**Re: Amity Oaks Subdivision (PR#47-2025)
City of Amity (PWS ID#00041)
Conditional Approval**

The project includes the installation of a new 8" C-900 waterline along Amity Oaks Ln. to serve a new 36-lot, 3-phase subdivision called "Amity Oaks", in Amity. The developer of the subdivision is Community Home Builders, which is a non-profit organization that develops low-income housing.

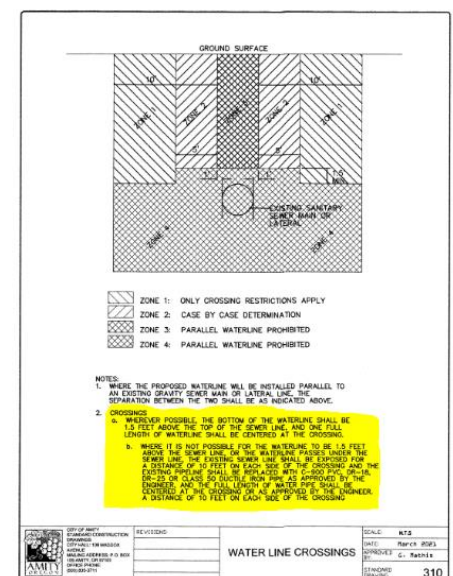
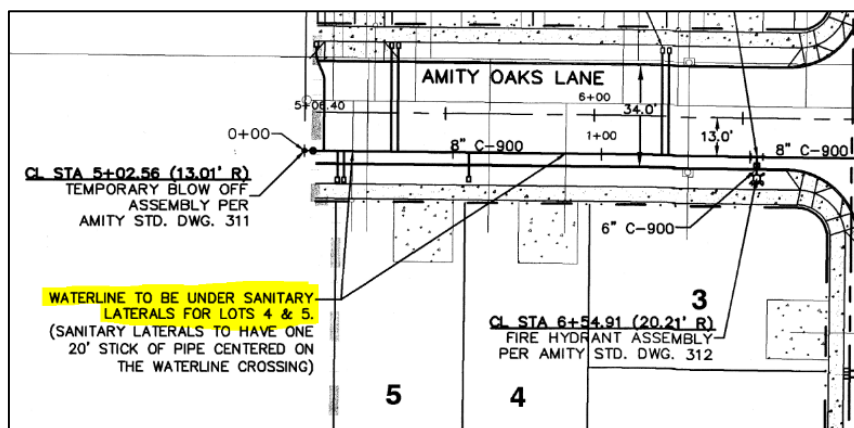
I did not see drawing RD336 in the submitted plans as noted on Sheet 36 →

1. The plan review fee is paid (final amount due is still pending).
2. All items in contact with potable water must meet NSF Standard 61 or equivalent.
3. The design must allow for 20 psi to be maintained at all service meters.
4. Disinfection of the waterline must be completed according to AWWA C651. Results from the coliform sampling must be provided to our office.
5. Non-conductive waterlines (e.g., 8" C-900) are installed with tracer wire in accordance with OAR 333-061-0050(8)(k) as shown below.

(k) Nonconductive water pipe (plastic or other material) that is not encased in conductive pipe or casing must have an electrically conductive wire or other approved conductor for locating the pipe when the pipeline is underground. The wire shall be No. 18 AWG (minimum) solid copper with blue colored insulation. Ends of wire shall be accessible in water meter boxes, valve boxes or casings, or outside the foundation of buildings where the pipeline enters the building. The distance between tracer lead access locations shall not be more than 1,000 feet. Joints or splices in wire shall be waterproof.

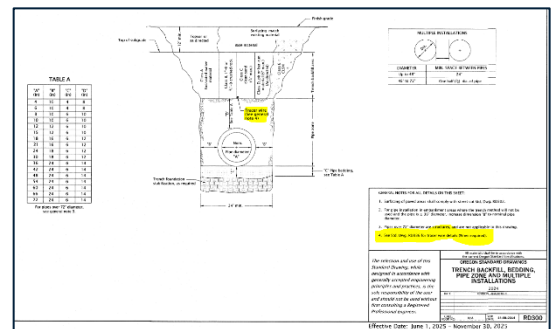
6. Where the waterline crosses under a sanitary sewer main or lateral, one full 20-ft length of water pipe must be centered under the lateral, with 10-ft of waterline extending on either side of the lateral as per the detail on Sheet 32 of the submitted plans →
 and as per OAR 333-061-0050(9), which is enclosed for reference.
